Date: August 15, 2018
To: Cumberland Planning Board
From: Carla Nixon, Town Planner
Subject: OceanView at Cumberland Major Subdivision Final Review

Date August 15, 2018
To Town of Cumberland Planning Board
From Carla Nixon, Town Planner
Subject **Major 52 Unit Major Subdivision, Final Review: OceanView at Cumberland – 277 Tuttle Road**

Subject: Planner's Comments for Ocean View

C1

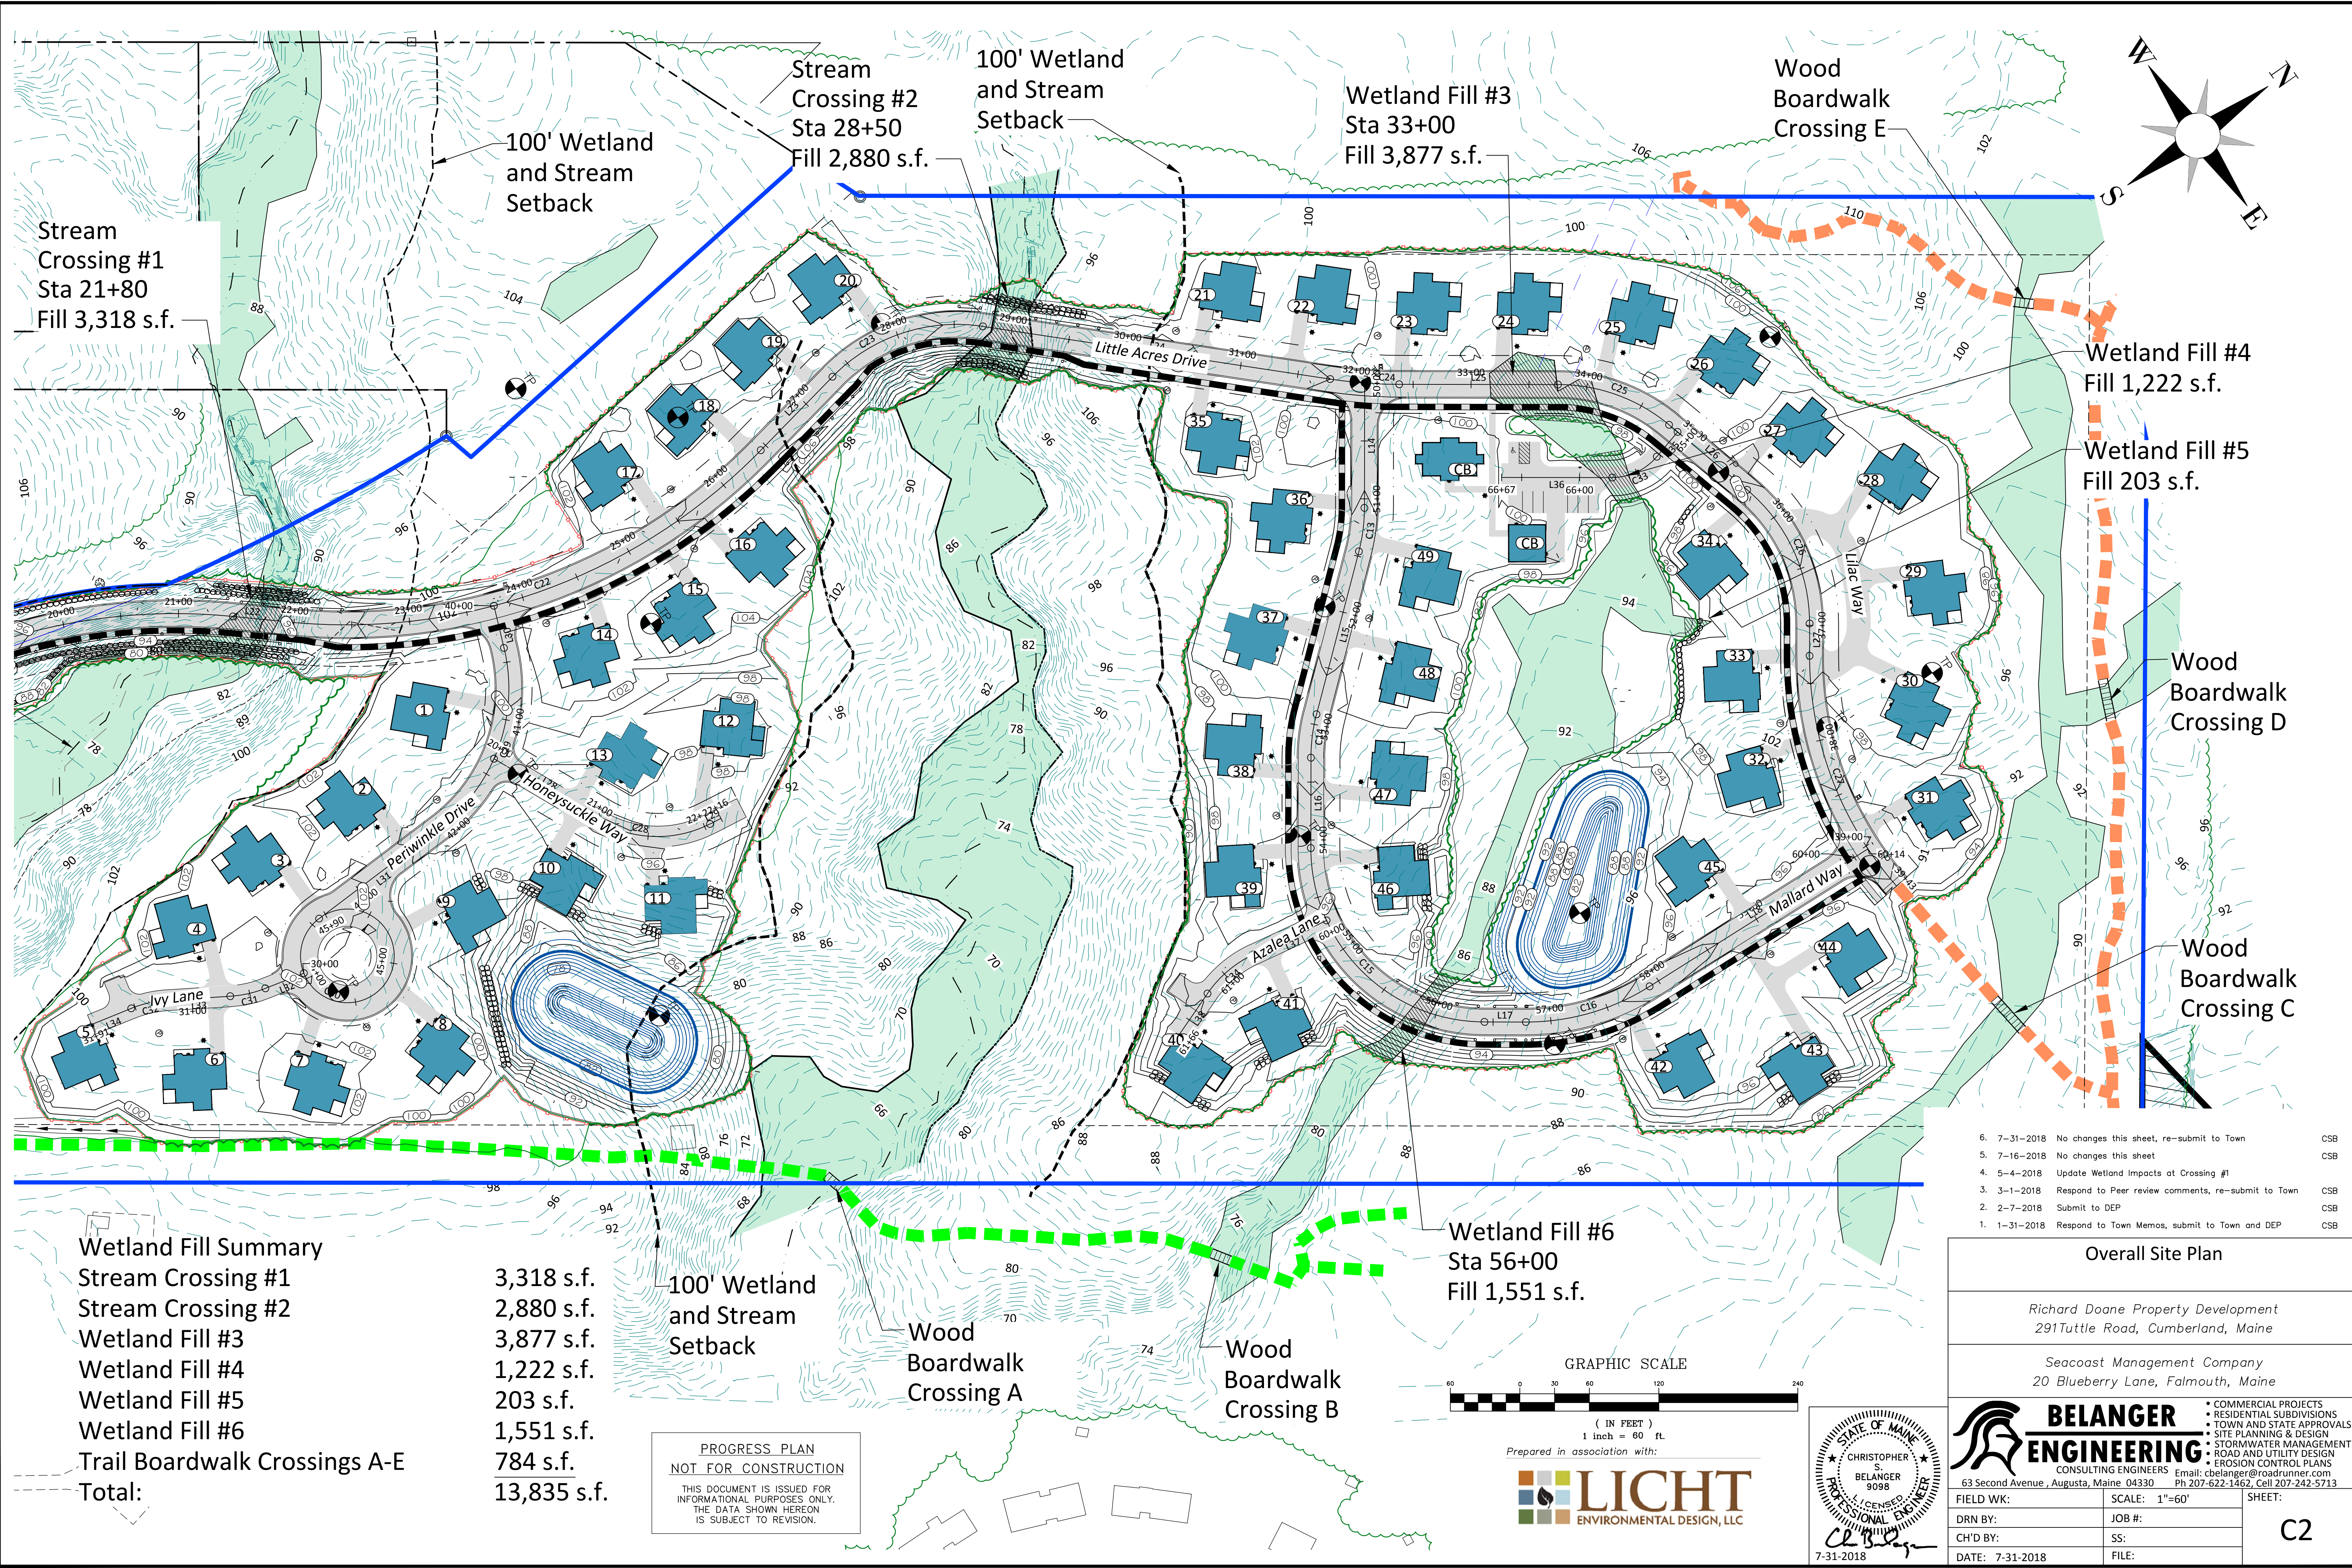
3. DOT Entrance Permit and Traffic Movement Permit: Status? Required? Attached. Submitted on March 16th. Copy Attached for ease of accessing.
4. On Sheet C1 there are small green circles shown with no legend reference. Meaning? These are simply surveyed pine trees (Along Tuttle Road and the beginning of Little Acres Drive) as a file layer. Not important to the Phasing plan.

28. Overall Plan Sheet C1 references a 50-foot buffer and golf cart trails not shown on the drawing.

C8

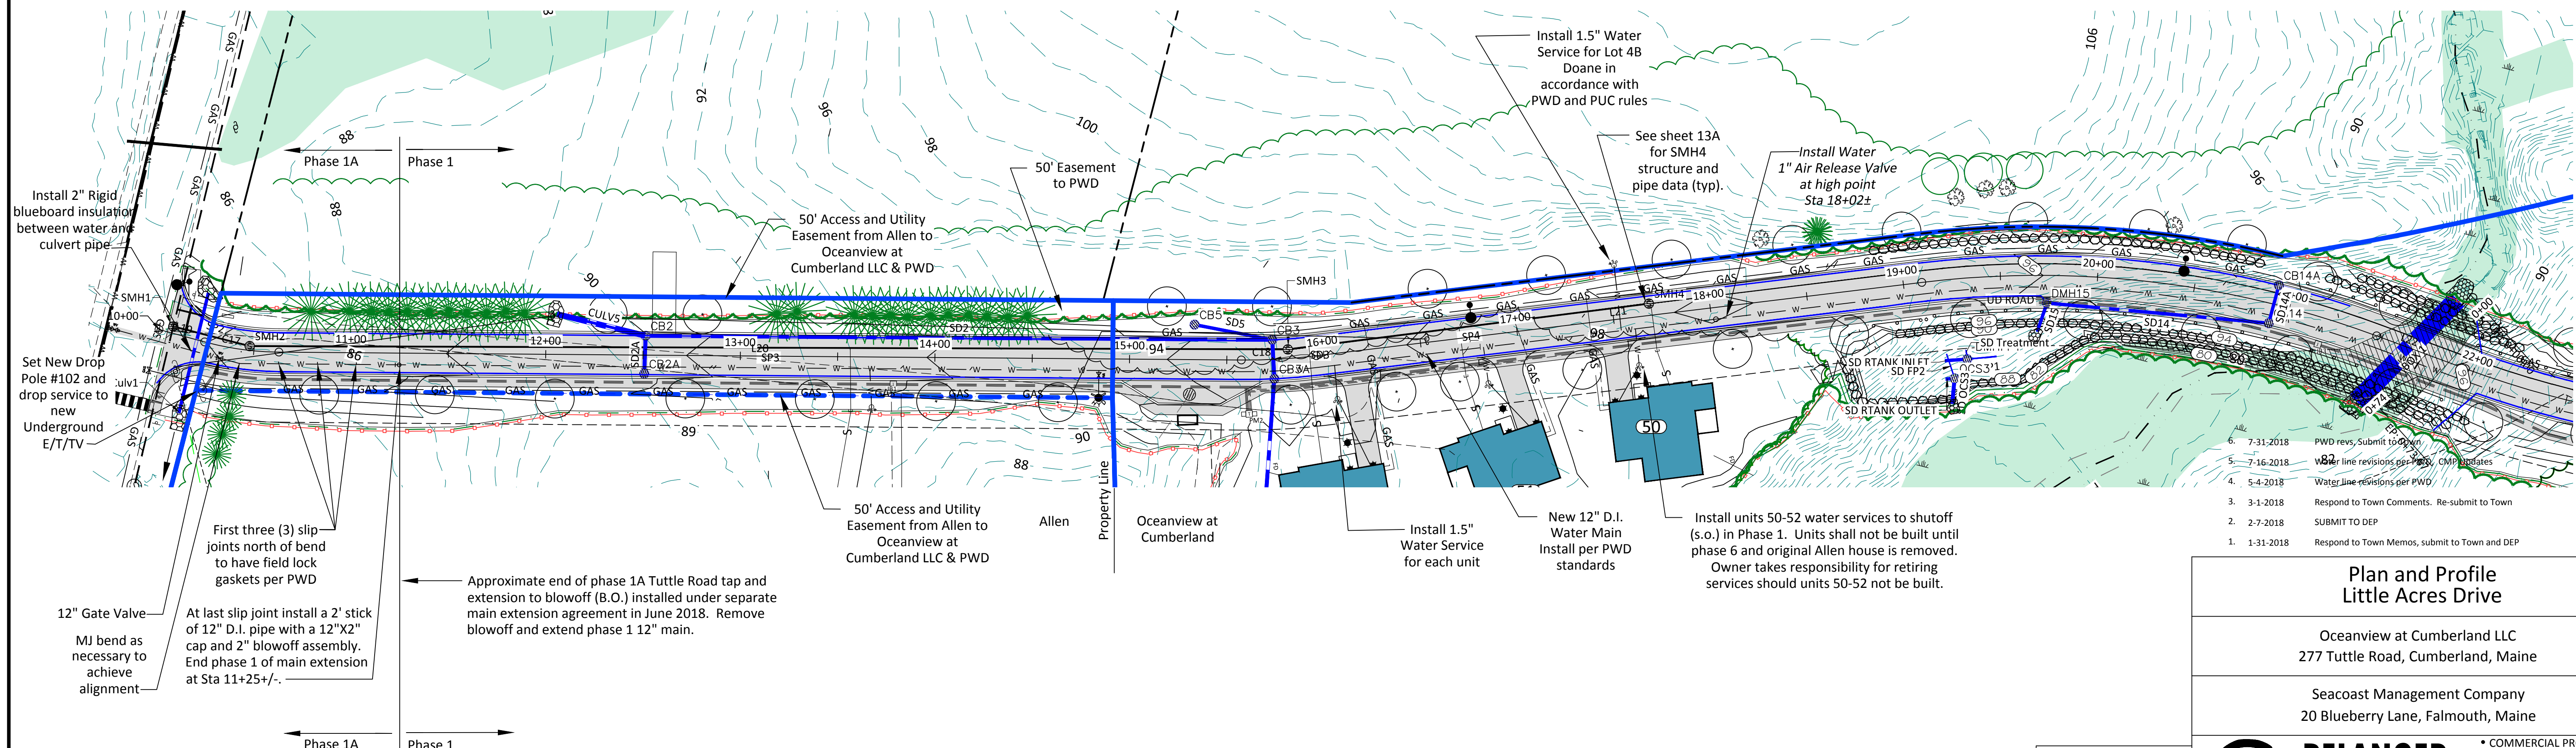
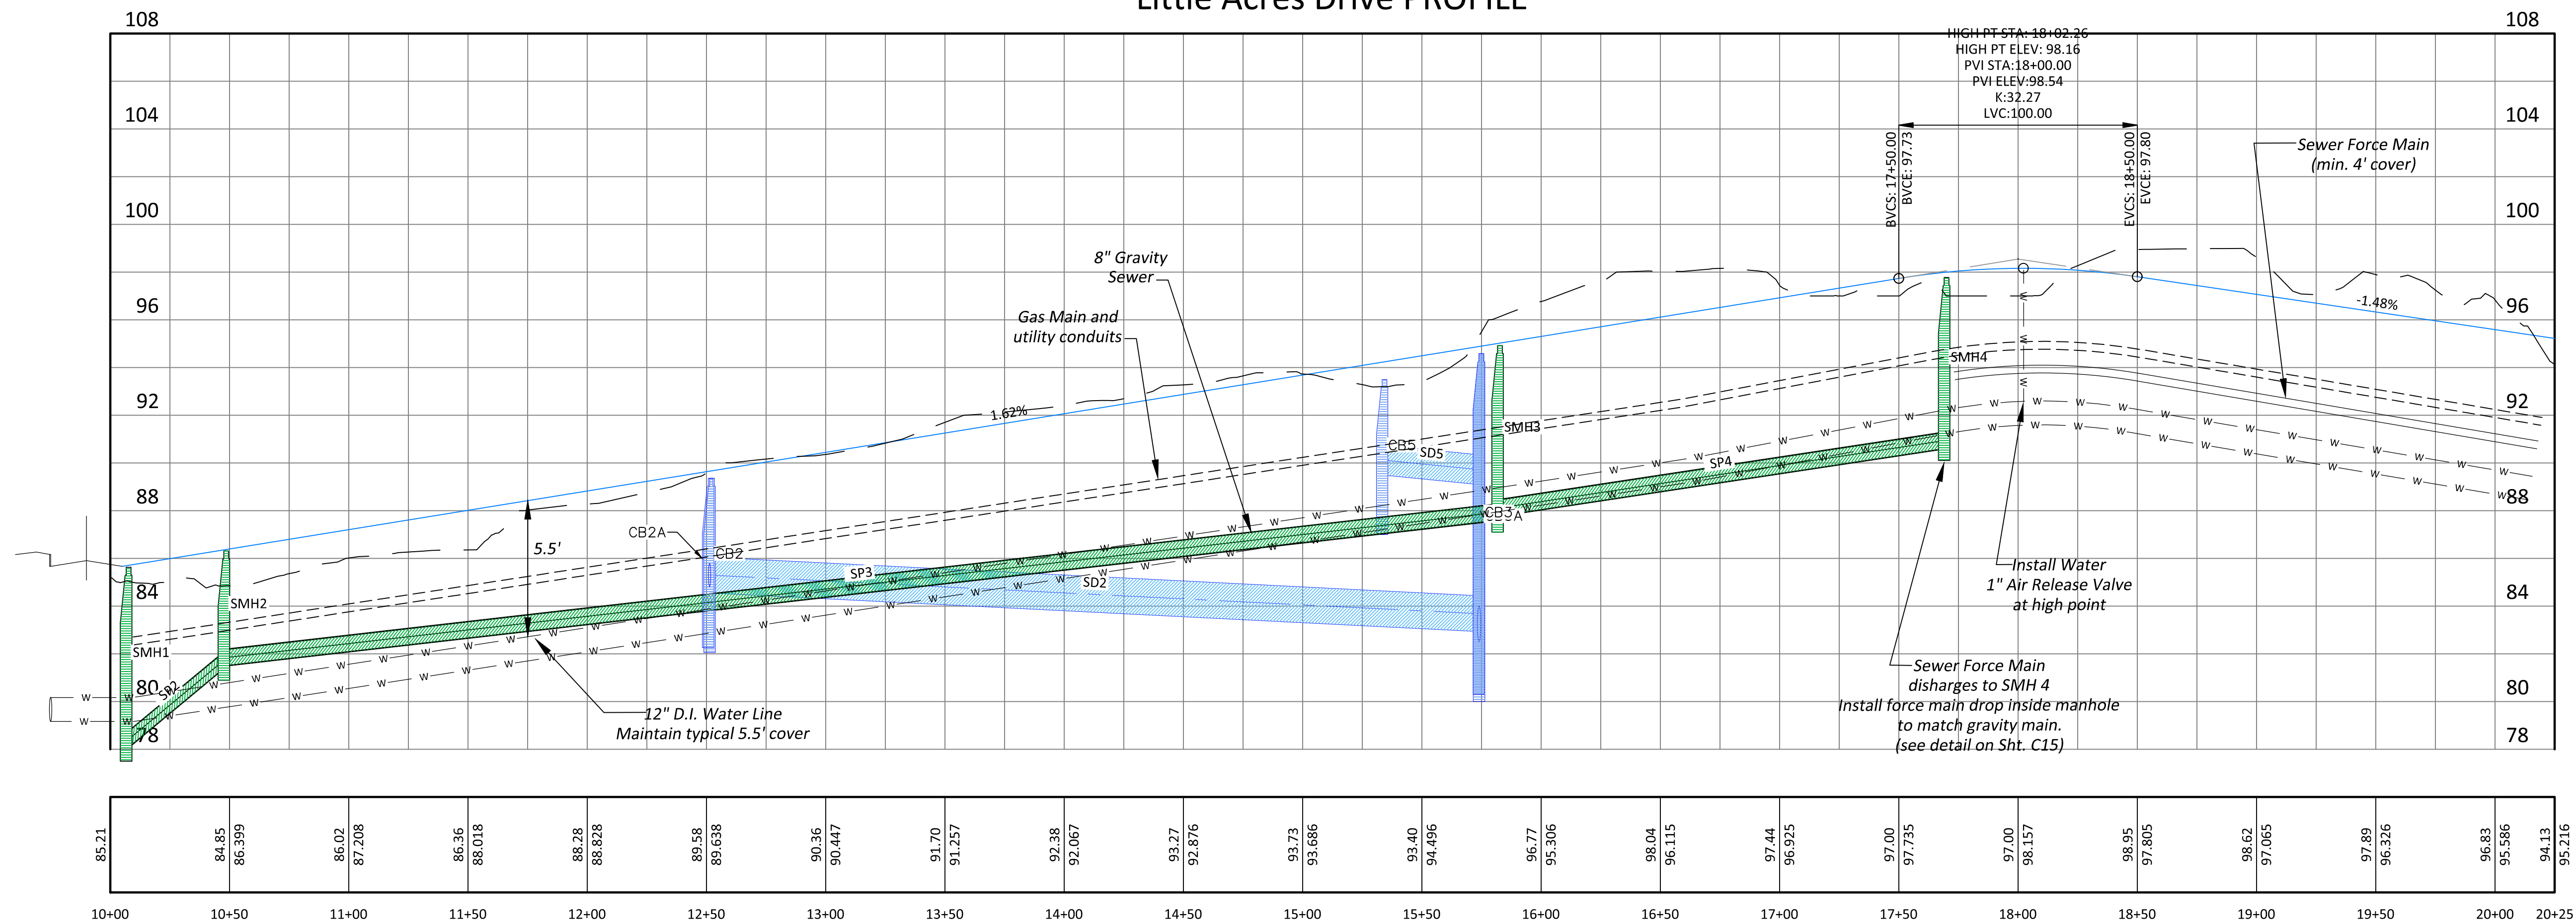
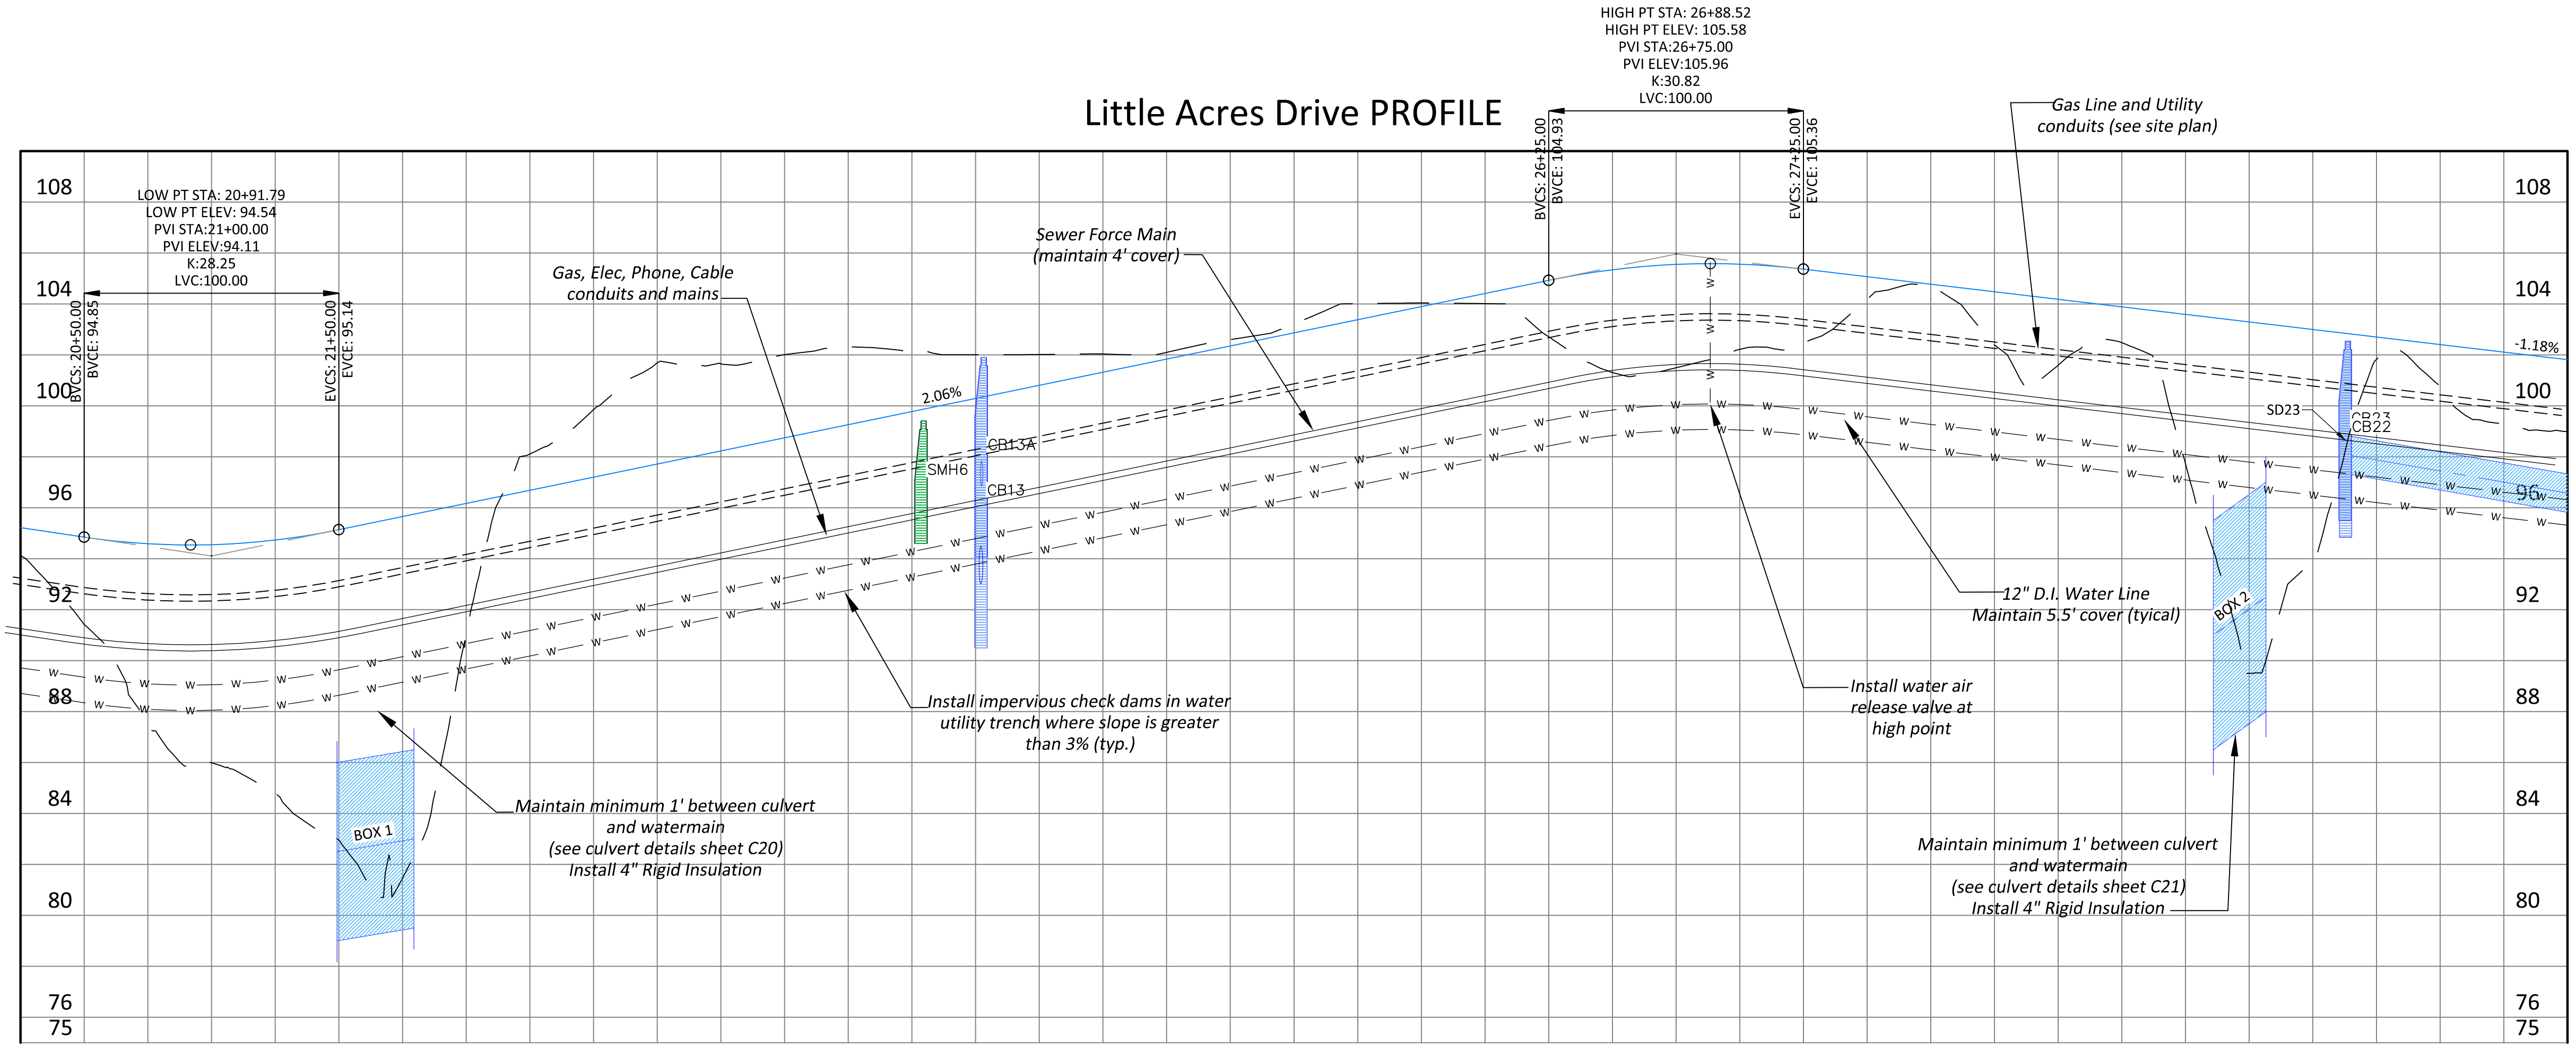
29. On sheet C-8, Little Acres Drive profile section at STA 38+75 appears to have some information overlaid onto the profile section that makes that portion of the plan difficult to interpret. Please clarify.
